Access Compliance Report

Public Rights-of-Way

Main Street: EDINGER_AVE Cross Street: HARBOR_BLV Location: NE

ADA ID: RPRK220222153229 Ramp Type: Type 1 - Perpendicular Diagonal Initial Pass/Fail: Pass Overall Compliance: No Severity Score: 2

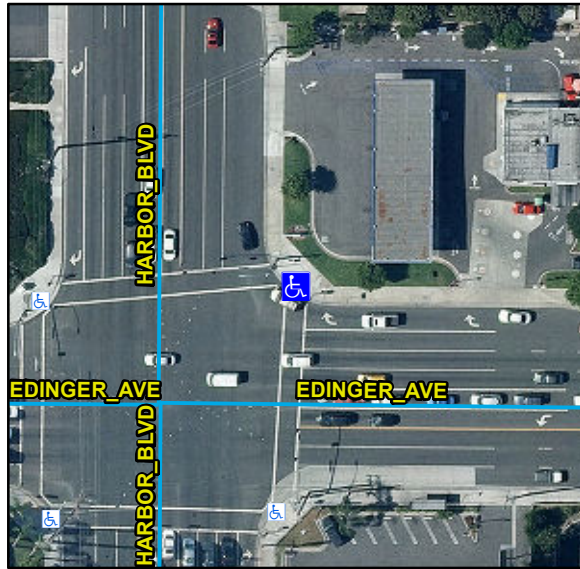
Remove & Replace Landing.
